BRADLEY HEIGHTS

JOB NO:	3227
DATE:	4/6/2022
DESIGNED BY:	PEG
DRAWN BY:	PEG
CHECKED BY:	PEG
APPROVED BY:	Paul Green

SITE PLAN

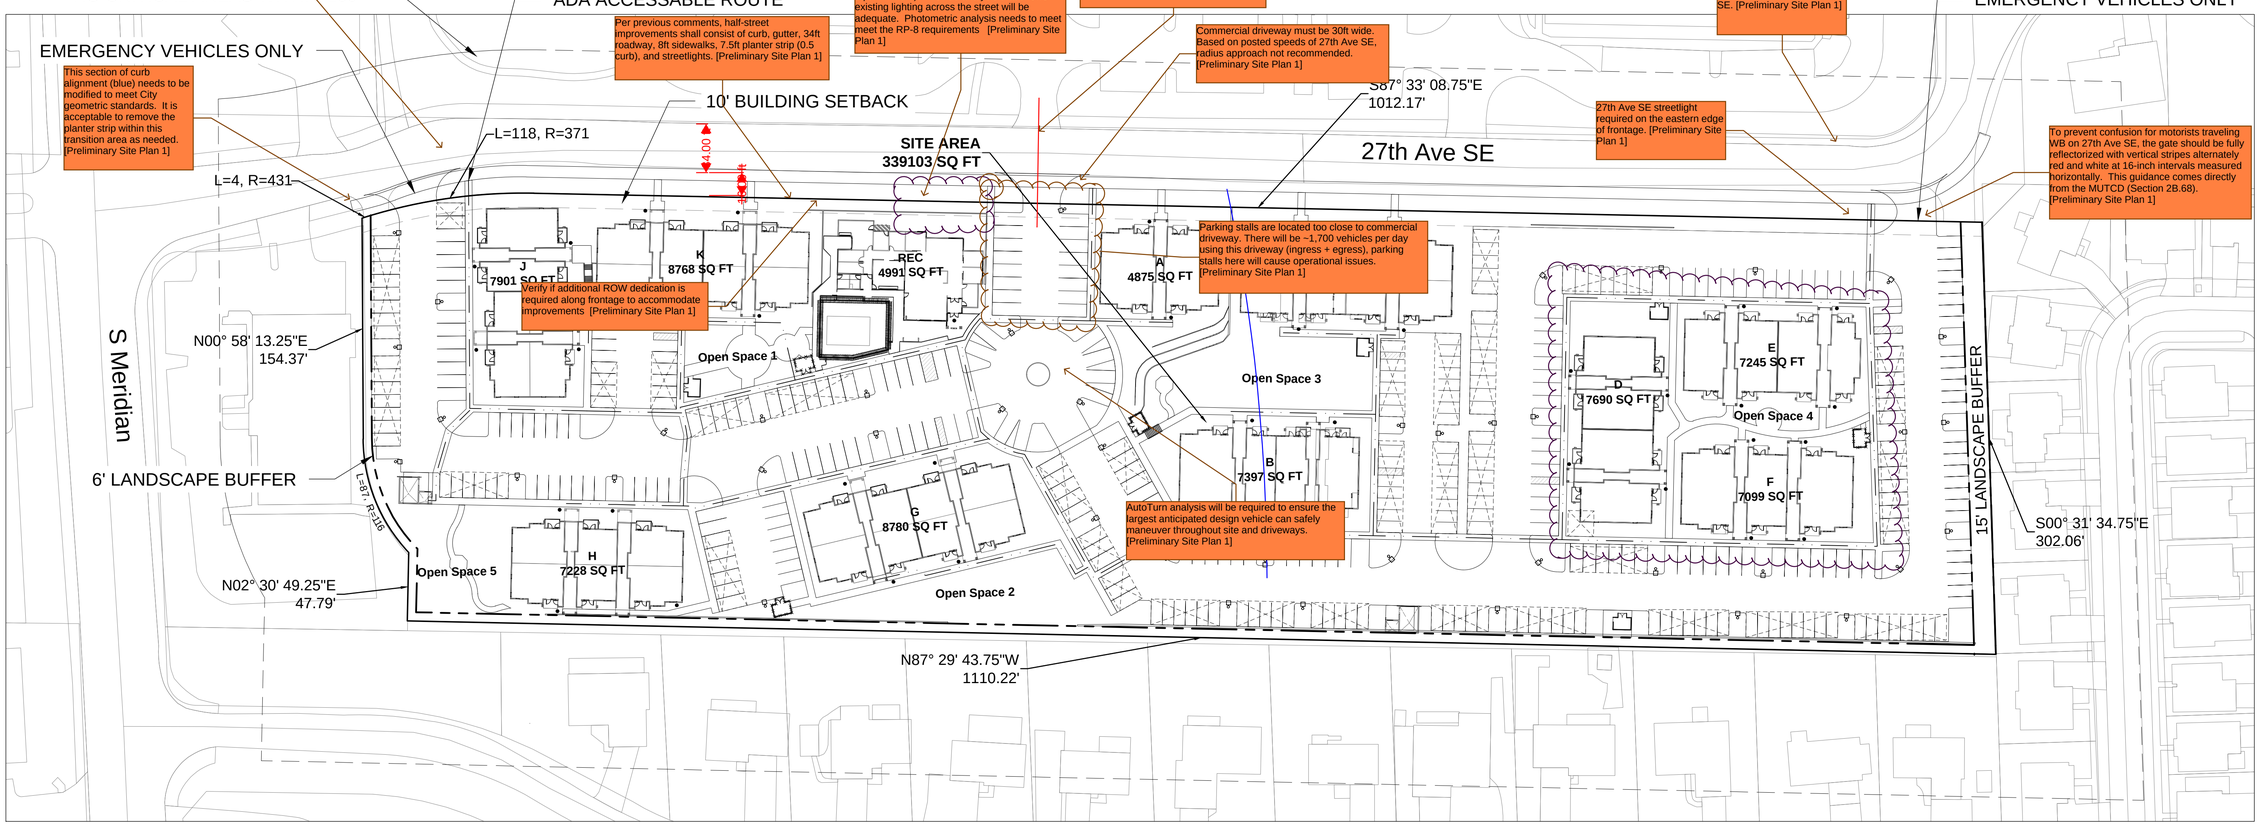
During civil review, provide channelization design that matches the updated geometry/curvature. [Preliminary Site Plan 1]

This section of curb alignment (blue) needs to be modified to meet City geometric standards. It is acceptable to remove the planter strip within this transition area as needed. [Preliminary Site Plan 1]

Per previous comments, half-street improvements shall consist of curb, gutter, 34ft roadway, 8ft sidewalks, 7.5ft planter strip (0.5 curb), and streetlights. [Preliminary Site Plan 1]

Show location of PSD bus stop pad behind sidewalk. Sizing per PSD requirements (300 sqft minimum). Provide analysis that shows existing lighting across the street will be adequate. Photometric analysis needs to meet meet the RP-8 requirements [Preliminary Site Plan 1]

Centerline of commercial access must be aligned with SHAG driveway across the street. [Preliminary Site Plan 1]

Commercial driveway must be 30ft wide. Based on posted speeds of 27th Ave SE, radius approach not recommended. [Preliminary Site Plan 1]

ADA ramp must be removed on the north side of 27th Ave SE. [Preliminary Site Plan 1]

27th Ave SE streetlight required on the eastern edge of frontage. [Preliminary Site Plan 1]

To prevent confusion for motorists traveling WB on 27th Ave SE, the gate should be fully reflectorized with vertical stripes alternately red and white at 16-inch intervals measured horizontally. This guidance comes directly from the MUTCD (Section 2B.68). [Preliminary Site Plan 1]

Verify if additional ROW dedication is required along frontage to accommodate improvements [Preliminary Site Plan 1]

Parking stalls are located too close to commercial driveway. There will be ~1,700 vehicles per day using this driveway (ingress + egress), parking stalls here will cause operational issues. [Preliminary Site Plan 1]

AutoTurn analysis will be required to ensure the largest anticipated design vehicle can safely maneuver throughout site and driveways. [Preliminary Site Plan 1]

Update Traffic Scoping worksheet to reflect the maximum number of units [Preliminary Site Plan 1]
